COMMONWEALTH OF KENTUCKY
BEFORE THE PUBLIC SERVICE COMMISSION

DUKE ENERGY KENTUCKY, INC.'S)	
INTEGRATED RESOURCE PLAN)	Case No. 2018-00195
)

PETITION OF DUKE ENERGY KENTUCKY, INC.
FOR CONFIDENTIAL TREATMENT OF CERTAIN RESPONSES TO
COMMISSION STAFF'S FIRST REQUEST FOR INFORMATION
AND TO THE KENTUCKY ATTORNEY GENERAL'S OFFICE'S
FIRST REQUEST FOR INFORMATION

**Duke Energy Kentucky
Case No. 2018-00195
Attorney General's First Set Data Requests
Date Received: February 4, 2019**

Figure 1.1: Duke Energy Kentucky 2018 Integrated Resource Plan

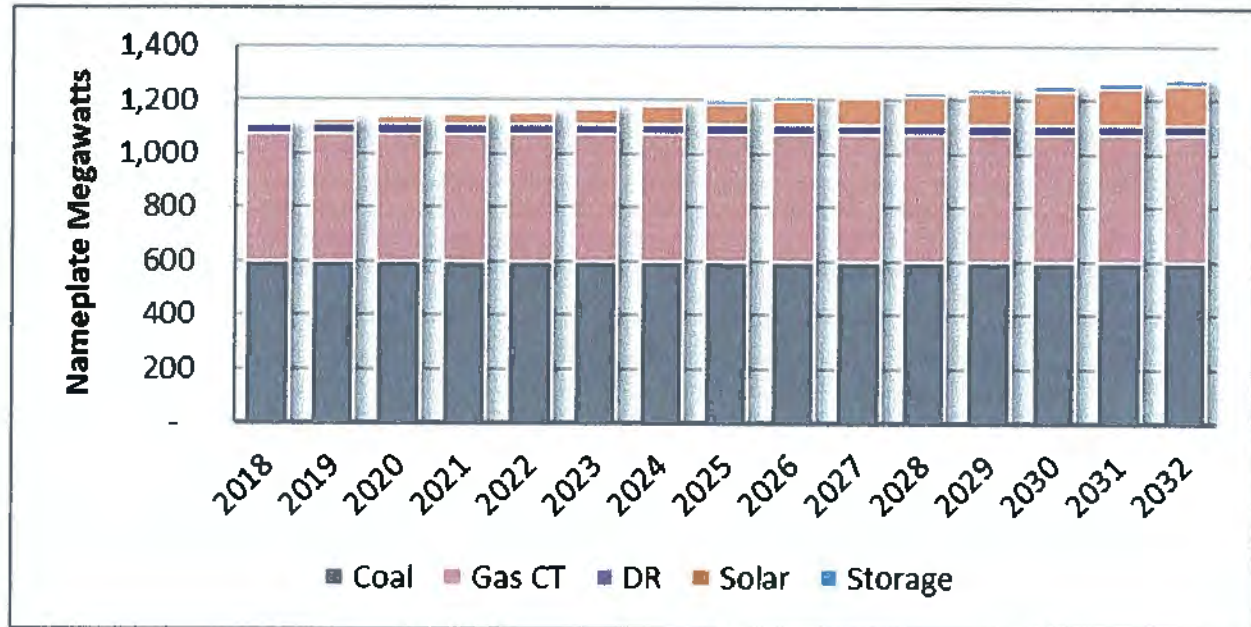
- e. Update figure 1.1 with DEK’s plan following the Commission’s investigation of DEK’s DSM programs.

- d. See response to a.
- e. Please see AG-DR-01-003(e) Attachment.
- f. Please see AG-DR-01-003(f) Attachment.
